Form 9-331 C (May 1963)

b. TYPE OF WELL			SINGLE MUL. ZONE ZONE	riple	S. FARM OR LEASE NAME Aztec 3 4
Ladd Petro	leum Corp.				9. WELL NO. 2-34
3. ADDRESS OF OPERATOR BOX 208, F	armington, NM {	37401			10. FIELD AND POOL, OR WILDCAT Harper Hill Fruitland
At surface  At proposed prod. zon	<del>1450</del> FSL - 1540 いとの。	)' FWL	th any State requirements.*)		11. SEC., T., R., M., OR BLK. AND SURVEY OR AREA  Sec 34 T30N R14W

### NEW MEXICO OIL CONSERVATION COMMISSION WELL LOCATION AND ACREAGE DEDICATION PLAT

DEPARTMENT OF THE INTERIOR GEOLOGICAL SURVEY  SUNDRY NOTICES AND REPORTS ON WELLS Do not use this form for proposals to drill or to deepen or plug back to a different exercit. Use from 9-331-0 for such proposals.)  SUNDRY NOTICES AND REPORTS ON WELLS Do not use this form for proposals to drill or to deepen or plug back to a different exercit. Use from 9-331-0 for such proposals.)  SUNDRY NOTICES AND REPORTS ON WELLS Do not use this form for proposals to drill or to deepen or plug back to a different exercit. Use from 9-331-0 for such proposals.)  SUNDRY NOTICES AND REPORTS ON WELLS  Do not use this form for proposals to drill or to deepen or plug back to a different exercit. Use

# TORUS BLOWOUT PREVENTER PATENTED

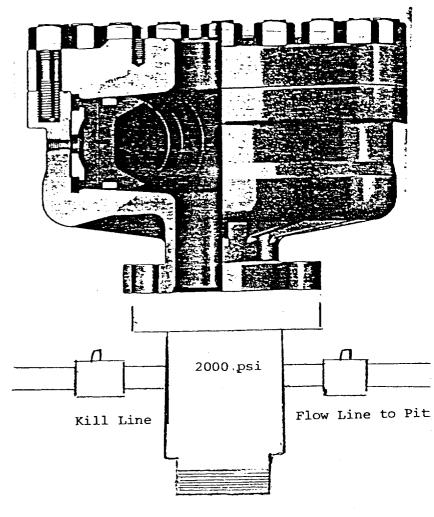
Install BOP after setting surface pipe and pressure test to 1000 psi after drilling out from under surface pipe.

2. Plan to set 90' of 7" surface pipe and cement to surface w/20 sx	•
1 1 1 1 1 1 1 1 1 1 1 1 1 1 1 1 1 1 1	•.
1 1 1 1 1 1 1 1 1 1 1 1 1 1 1 1 1 1 1	
3. Plan to use BOP as required by USGS. (6" 600 series)	
1 Section 1 Sect	4 1979
	COM
